DEXUS ESTATE INDUSTRIAL PARK PROJECT (MP 08_0259) MODIFICATION (MOD 2) – SUPERLOT C AMENDMENT – ADDITIONAL INFORMATION

**RE: MODIFICATIONS TO THE PROJECT APPROVAL FOR DEXUS ESTATE,
PRECINCT C, SOUTHERN EMPLOYMENT LANDS, GREYSTANES**

Figure 1: Basalt Road – As Approved (Source: Approved Plan MP08.05, Masterplan Lot B)

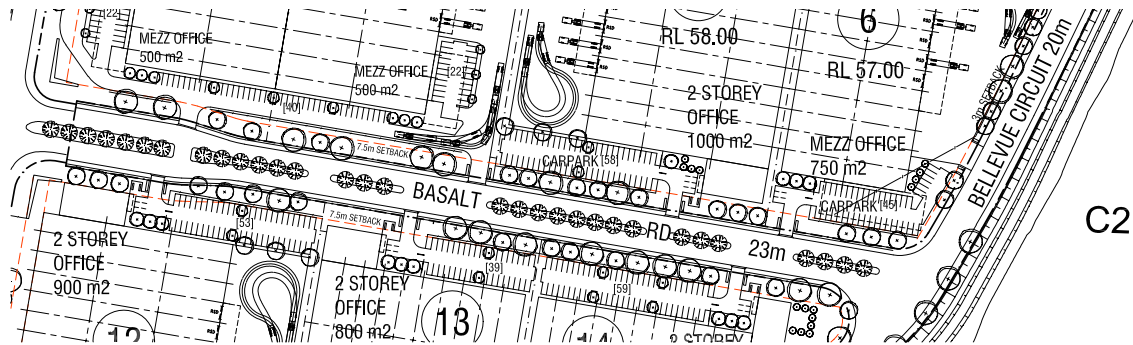
a) The previous master plan showed all driveways on the southern side of Basalt Road offset from the driveways on the northern side of Basalt Road. In addition the "for construction" subdivision plan submitted to Council had the central median on Basalt Road continuous from Reconciliation Road to Bellevue Circuit.

To clarify, the approved masterplan for the DEXUS Estate has a number of breaks in the median strip on Basalt Road (see **Figure 1**). These breaks enable more efficient access into and out of the individual development lots, avoiding the need for extended and inefficient traffic movements within the estate to gain access to lots.

DEXUS acknowledges that the road has been constructed with a continuous median (see **Figure 2**), which followed detailed construction design planning with Council. DEXUS was of the understanding that the breaks would be re-incorporated into the median, based on the final lot layout for lots fronting the road, and accompanied by appropriate traffic assessment demonstrating the acceptability of the breaks on traffic grounds.

Notwithstanding the above, due to pressing construction deadlines for the UPS Facility (ie. Warehouse 8) and Warehouse 9, DEXUS agrees to leaving the median continuous as constructed in the interim. However, DEXUS proposes to reincorporate the breaks, to the satisfaction of Council, in conjunction with an application for approval of one of the residual warehouses in Superlot C (or alternatively via a separate approval under the *Roads Act 1993*). The location of any breaks would be supported by modelling demonstrating the acceptability of the breaks in terms of traffic operation and performance.

Figure 3: Basalt Road – As Originally Proposed in MOD 2 (Source: Plan MP.08.2 Rev. G)

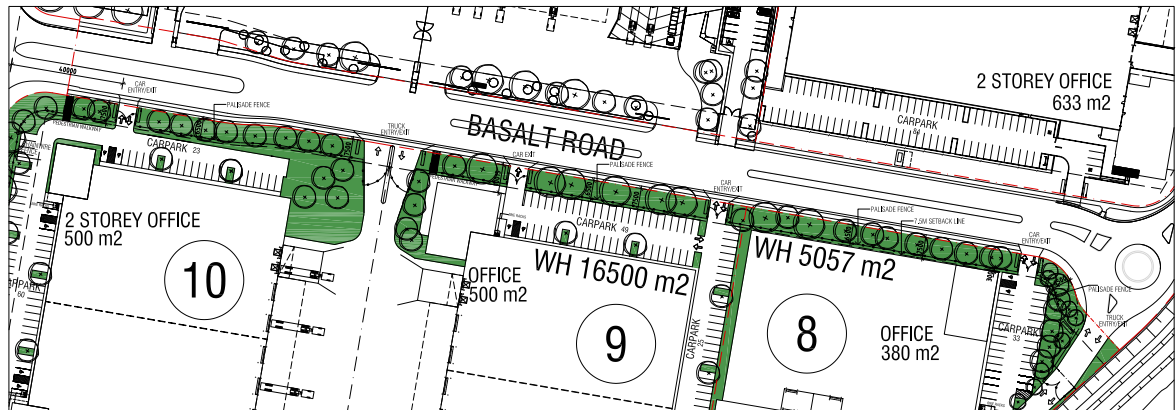
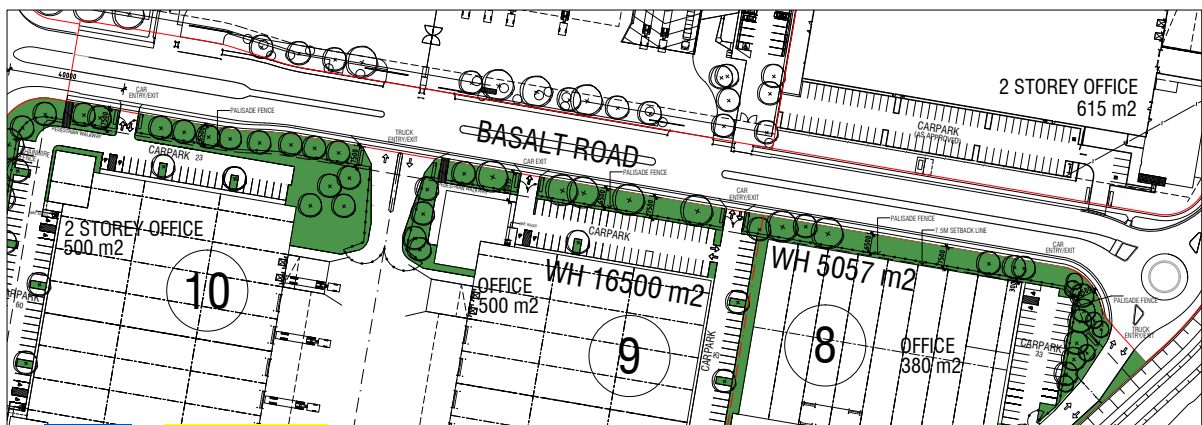
b) The central median on Basalt Road is proposed to have a break to allow right turn movements in and out of Lot 9, Lot 10 & Lot 11 loading dock driveway. In addition the loading dock driveway is proposed to be directly opposite the loading dock driveway for Lot 5 forming an intersection. This will cause a major right turn conflict point on Basalt Road. The traffic report used SIDRA Intersection to analyse the intersection. SIDRA is not suitable for modeling an intersection which is solely used for heavy vehicles. It is also noted that SIDRA does not model road safety impacts of intersections.

c) The central median on Basalt Road is proposed to have a break to allow right turn movements in and out of Lot 9 car park driveway. In addition, the driveway will be opposite the car park driveway for Lot 5. This will cause another right turn conflict point on Basalt Road.

To address this issue, DEXUS has amended the breaks in the median in Basalt Road by limiting the number of breaks to two, and strategically locating the breaks to avoid traffic conflicts. The breaks as originally proposed in the modification application (MOD 2) are shown on **Figure 3**, and the amended breaks are shown on **Figure 4**. The revised architectural plans are attached in **Appendix B**.

As outlined above, DEXUS has amended the breaks in the median in Basalt Road by limiting the number of breaks to two. The proposed breaks in the median provide right turn access to/from the loading dock area of Lots 9, 10 and 11 (located on the southern side of Basalt Road) and to/from the loading dock area of Lot 5 (located on the northern side of the road).

The design of the access driveways to Lot 5 and 9 car parks in Basalt Road has been amended with the central median across these driveways maintained. As such, access to Lot 5 and 9 car parks would be restricted to left in and left out.

MODIFICATION MASTERPLAN
PRECINCT C

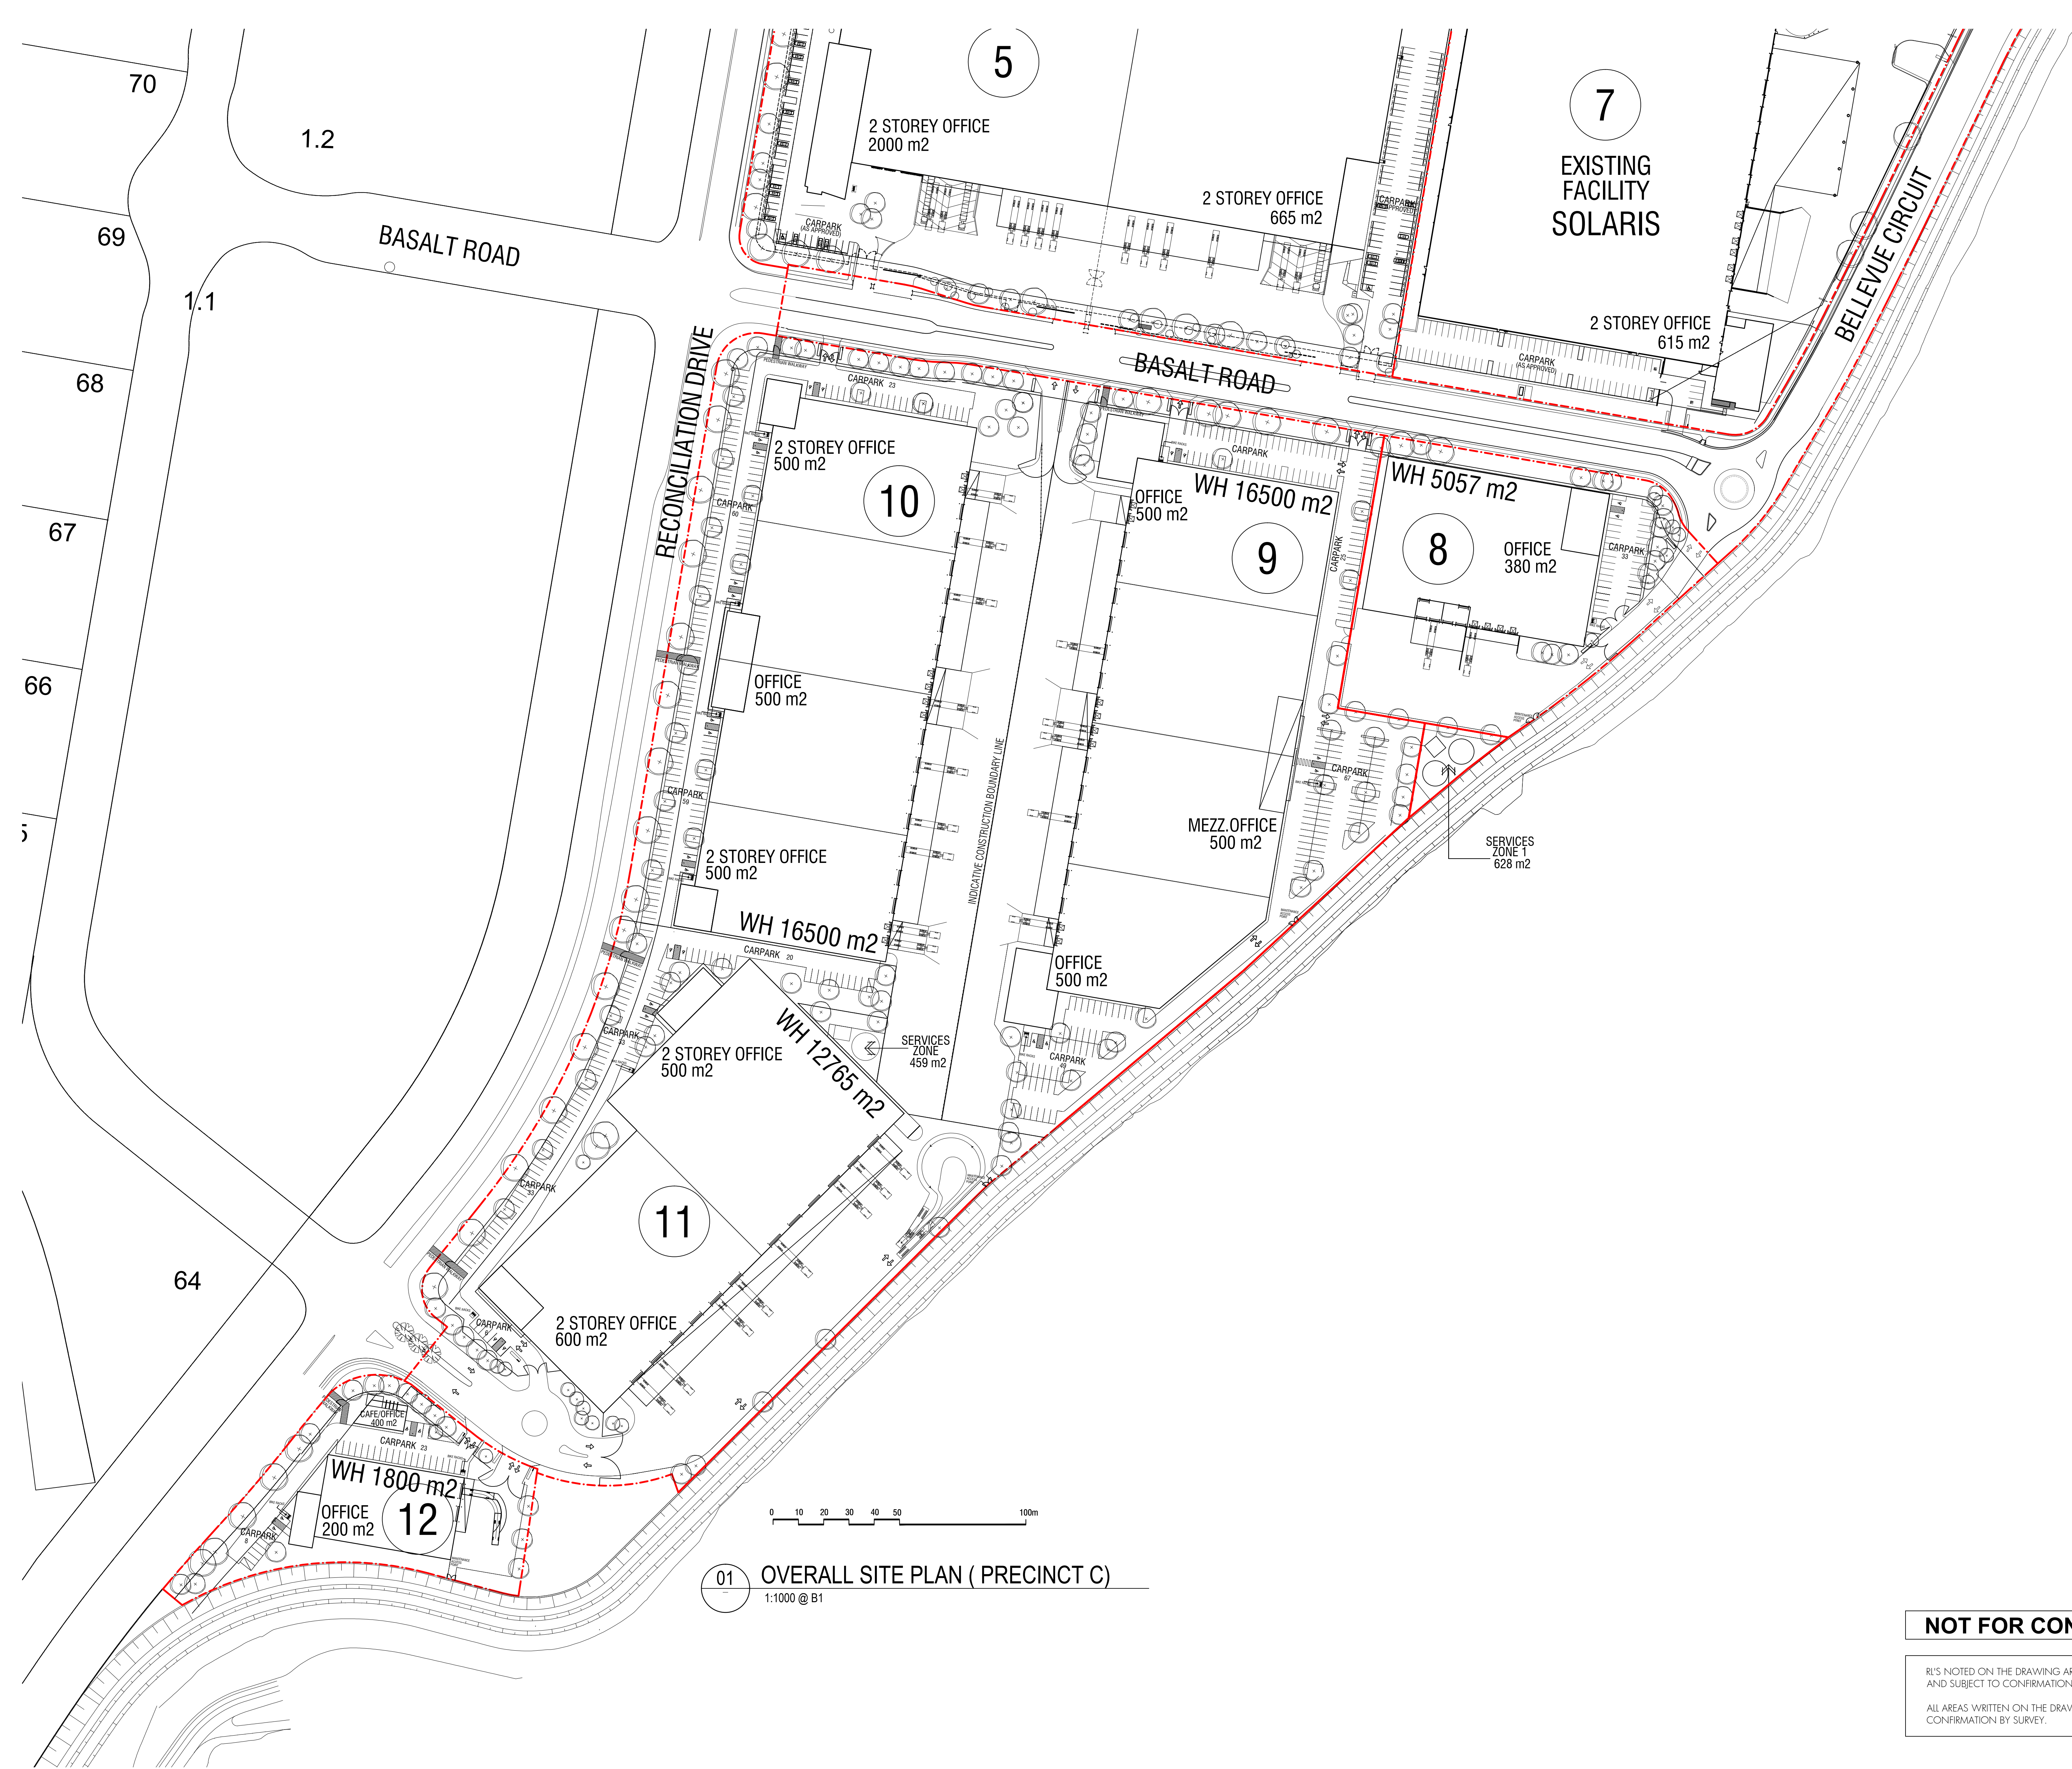
d) The central median on Basalt Road is proposed to have a break to allow right turn movements in and out of Lot 8 car park driveway which will cause another right turn conflict point. It is also noted that the car park driveway for Lot 8 is less than 6 metres from the tangent point of the intersection of Bellevue Circuit/Basalt Road and therefore does not comply with AS2890.1-2004. The break on the median should be removed and the car park access for Lot 8 be from the Lot 8 Loading Dock driveway (ie. southern approach of the Basalt Road/Bellevue Circuit roundabout intersection).

e) The impact of the subdivision on the proposed traffic signals along Reconciliation Drive requires RMS approval. Concern is raised regarding easement/public road dedication requirement at the southern signalised intersection (ie. near Lot 12). Concern is also raised regarding the operation of the signals when the gate is closed.

- maintaining the median in this location; and
- relocating the car park access driveway clear of the intersection of Bellevue Circuit/Basalt Road, with access to/from the Lot 8 Loading Dock driveway, in accordance with AS2890.1-2004 (see Plan MP.08.05 in **Appendix B**).

To address Council's concerns regarding the operation of the signals when the gates to Lots 11 and 12 are locked (ie. potentially restricting trucks from turning around when entering from the intersection), the layout of the residual section of Bellevue Circuit at this intersection has been amended to incorporate a cul-de-sac turning area, with the gates into Lot 11 relocated to the clear of the turnaround area (see Plan MP.08.05 in **Appendix B**).
